Economic Commission for Europe

Joint Meeting of Experts on the Regulations annexed to the European Agreement concerning the International Carriage of Dangerous Goods by Inland Waterways (ADN)

Proposals for amendments to the Regulations annexed to ADN other proposals

Diagram of Tank vessel with hold space/service space in cofferdam

Tank vessel with hold space/service space in cofferdam

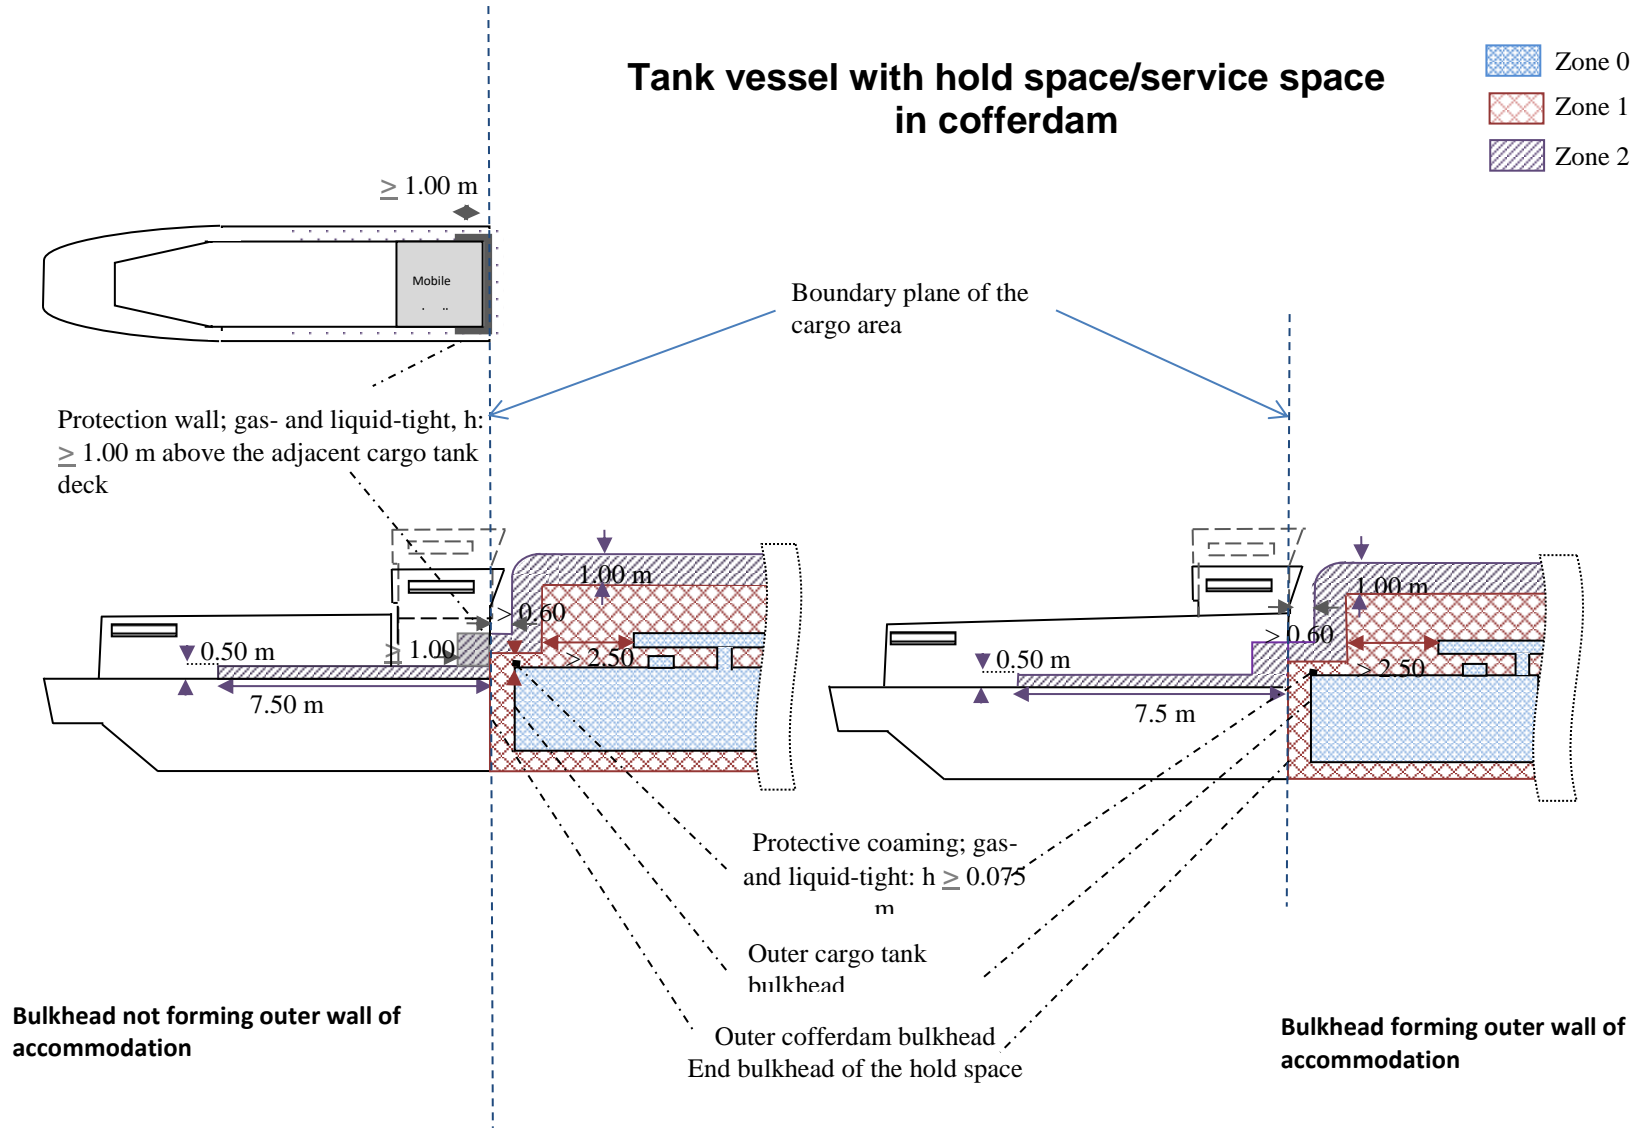
3. The drawings of the diagram of the Tank vessel with, and without, hold space/service space in cofferdam, did not reflect the difference that is indicated in the definition concerning the height and length of Zone 1.

4. There are two differences between cofferdams with and without service spaces: first the height is 0,25 m versus 1,00 m for cofferdams with and without service spaces

respectively, second Zone 1 runs up to the outermost cargo bulkheads versus to the “boundary plane of the cargo area” for cofferdams with and without service spaces respectively.

5. In the drawing of the diagram that is provided in this document, these differences are reflected in a more clear sense. Furthermore we added, for illustration purposes only, the incorrect drawing as it was illustrated in 2018/INF.21.
